STATE OF RHODE ISLAND
COASTAL RESOURCES MANAGEMENT COUNCIL
STAFF REPORT TO THE COUNCIL

Applicant's Name:	Susan LaChapelle Ropolo
CRMC File Number:	2021-05-075
Project:	Residential Boating Facility over SAV with tender lift
Location:	80 Washington Street; Newport: Plat(s): 12; Lot(s): 73
Water Type/Name:	Newport Harbor
Coastal Feature:	Coastal headland with Concrete Seawall
Plans Reviewed:	“Purpose: Construction of Timber Dock, Float, Gangway and Piles... 80 Washington St, Newport...” Dated 11/20/18 and last revised 12/13/2023 by Mount Hope Engineering.

Above: Aerial Image of subject lot (top), Walnut St ROW (with small vessels) and beach area to the south of the extension. Yellow dot indicates subject lot.

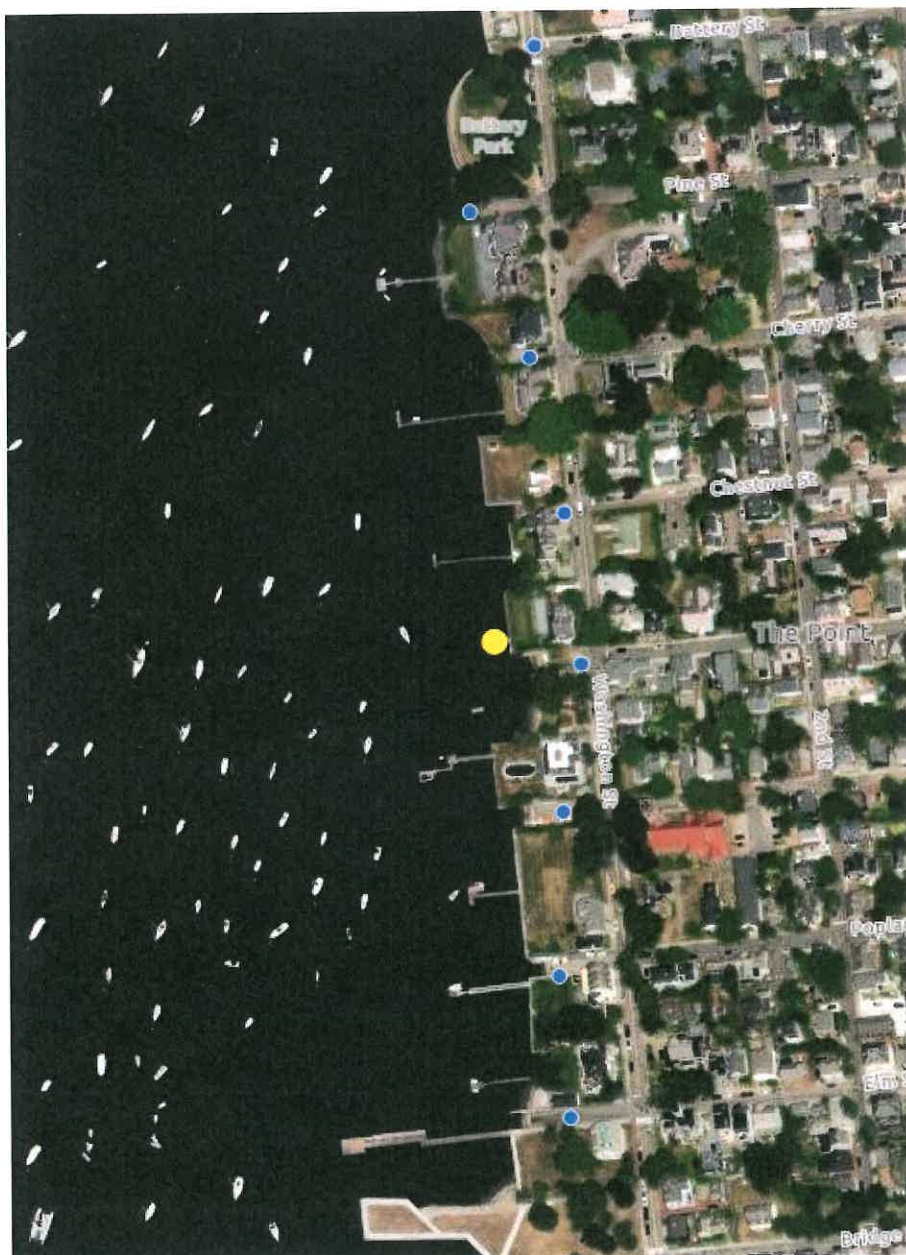
As can be seen in the below aerial imagery (DEM aerial photo, Winter 2022-2023), there is a sizable area of rocks at the southern corner of the subject lot in the waters at the end of Walnut St. extension./ROW At lower tides, it is unlikely that anyone utilizing this area to swim or launch small craft are doing so in this area, and possibly favoring the area in front of the southern residence which has no rocks. In fact, one letter calls out utilizing the beach in this area. However, rocks are underwater at higher tides, and it is possible that kayaks, paddleboards and tenders are launched in the area to the north near the affected property line.

While the facility has been placed at the top of the seawall and will provide access beneath it, the presence of the rocks as well as high tide also likely impedes lateral access in front of the subject lot.

Above: DEM Spring 2021 Imagery of southern portion of subject lot, Walnut St ROW, lot to the south with beach area (taken at a likely low tide). Yellow dot denotes subject property.

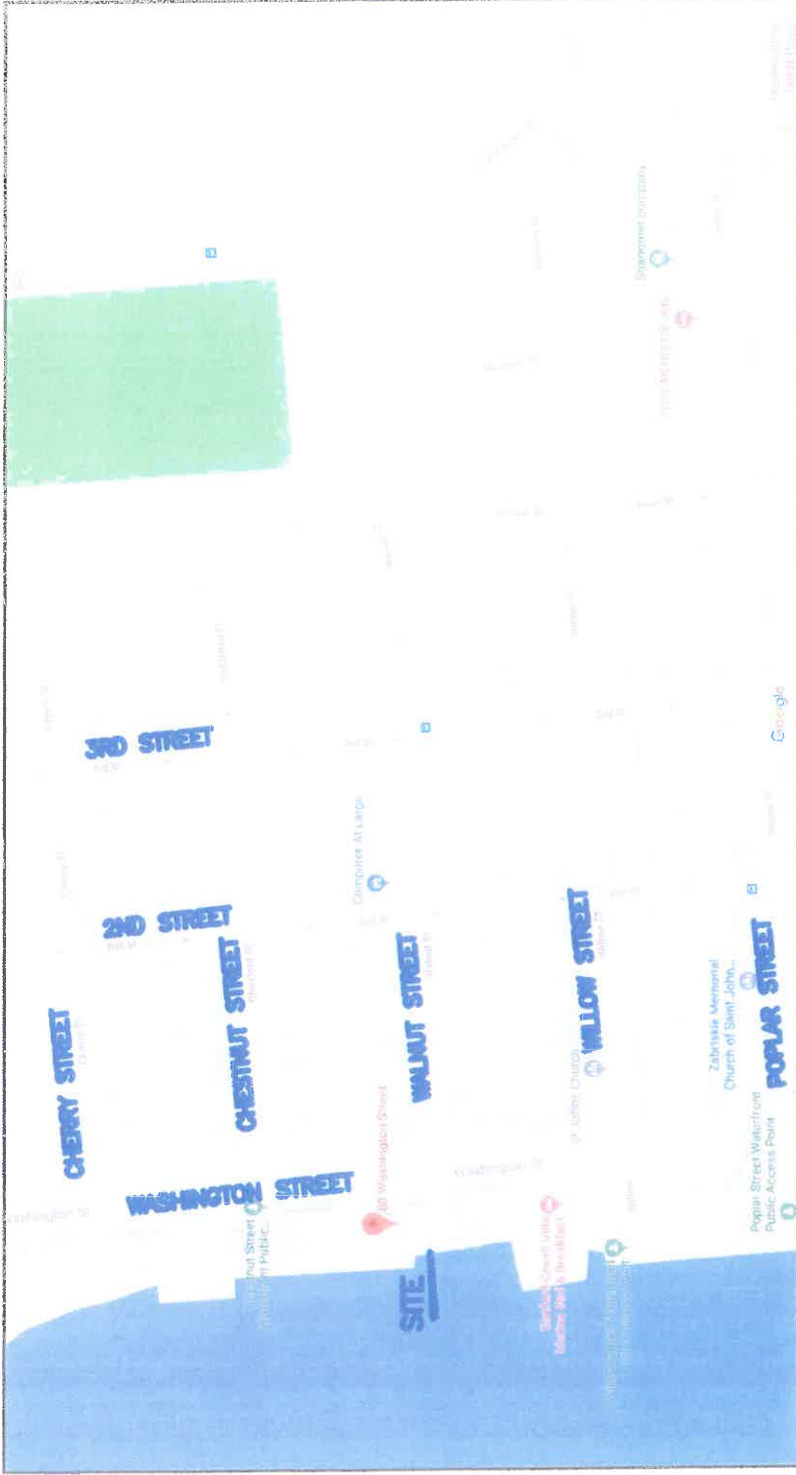
The proposed facility is located entirely within the property line extension of the subject property and does not intrude into the Walnut St ROW. The presence of the rocks at the southern property line where the facility will be sited likely limits recreational use of the waters immediately along the property line. The proposed facility is located 11-13' inside that property line and will only be utilized for touch-and-go purposes to access the owner's mooring -as required by the SAV regulations. Therefore it is staff's opinion that the facility is not likely to have significant adverse impacts on the public utilizing the Walnut St ROW to access the water, or utilizing the area of beach located in front of the southern portion of the ROW and in front of the lot to the south.

PLAN VIEW

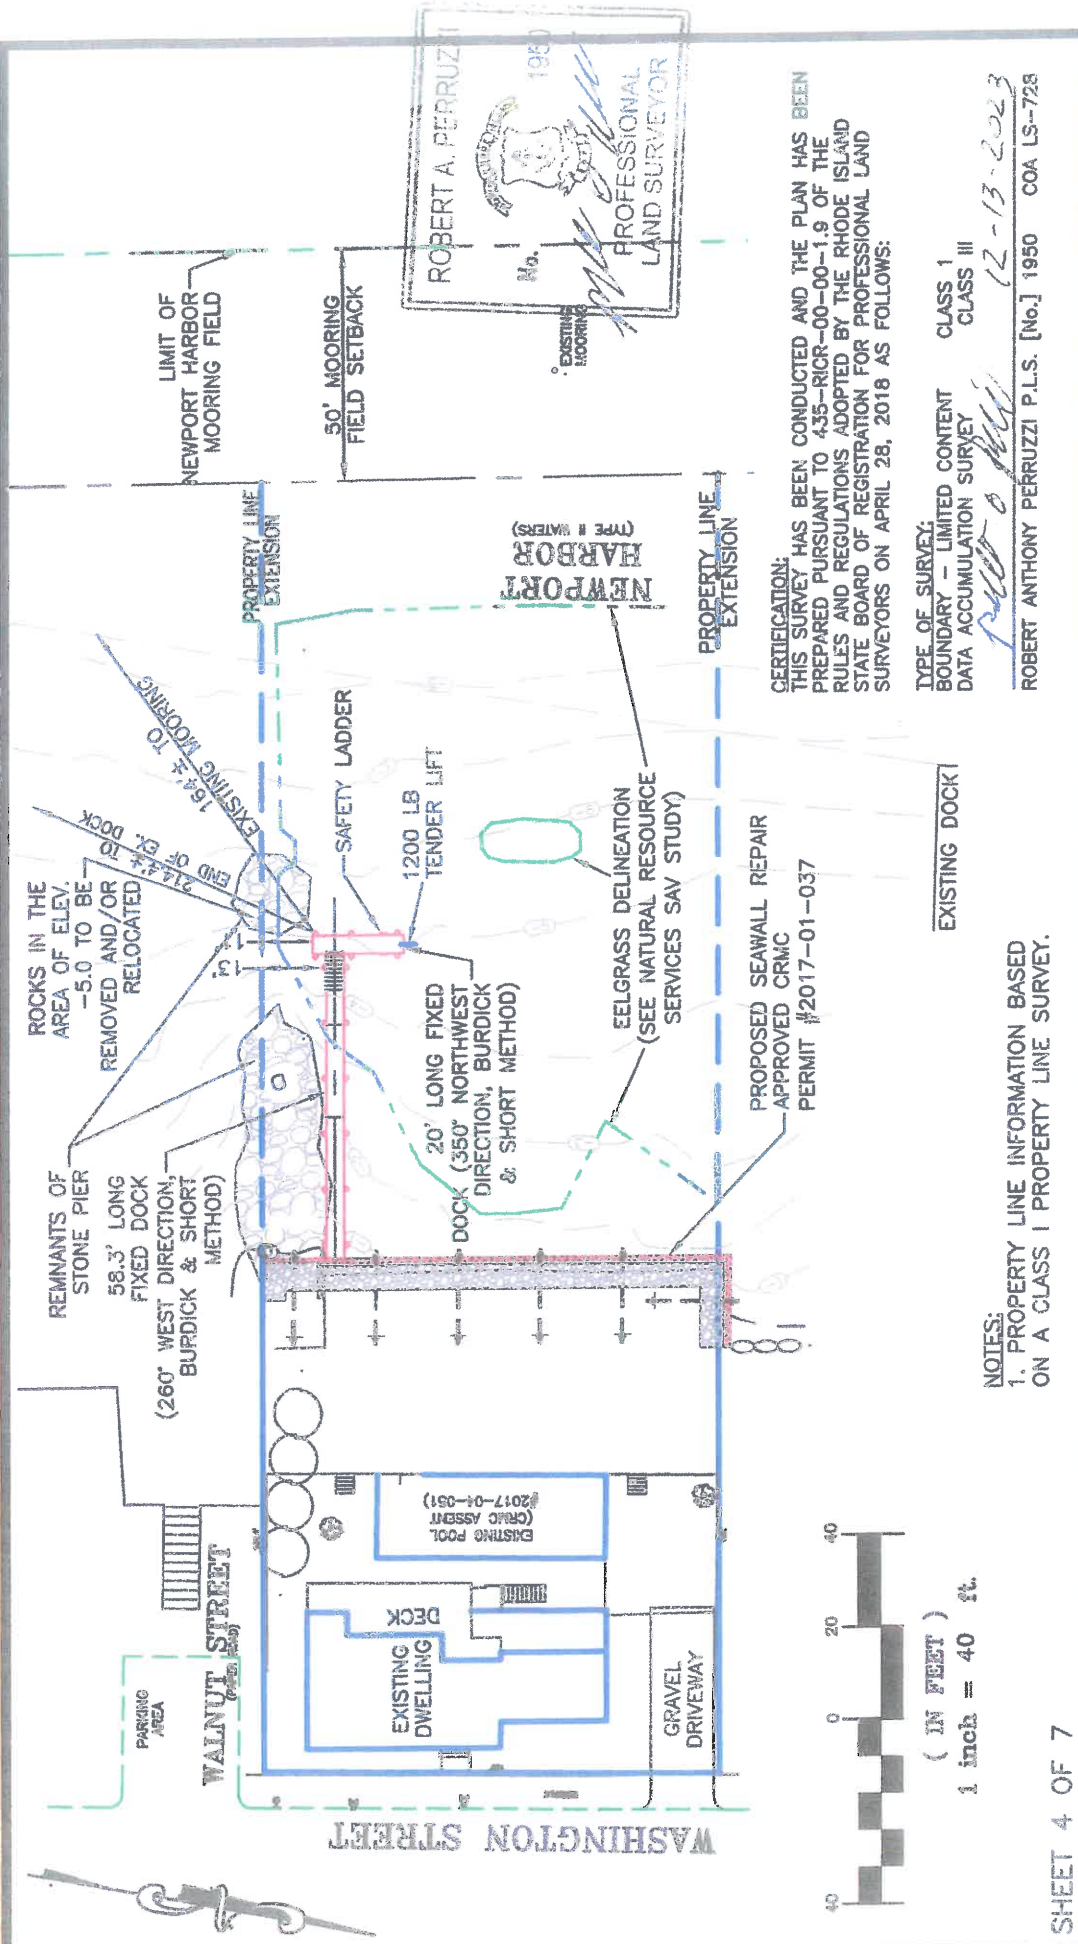
As proposed, the facility is 11 feet from the property line at its closest, and 13 feet away at its furthest. This is the location suggested by staff to least impact SAV resources, as the SAV does not extend as far seaward in the most southern portion of the lot's shoreline. As proposed, the facility is more than 40 feet from the property line extension of the dwelling to the south.

The applicant had submitted Variance Criteria for the original design, which was both length and side setback Variances. The revision has eliminated the length Variance, and new plans were submitted. No updated Variance request was submitted and is not considered necessary as the side setback Variance hasn't changed with the revisions. The applicant pointed out in the Variance request that the siting of the facility allows the least impact to the SAV identified along the entire waterfront of this lot. This is also the location staff recommended.
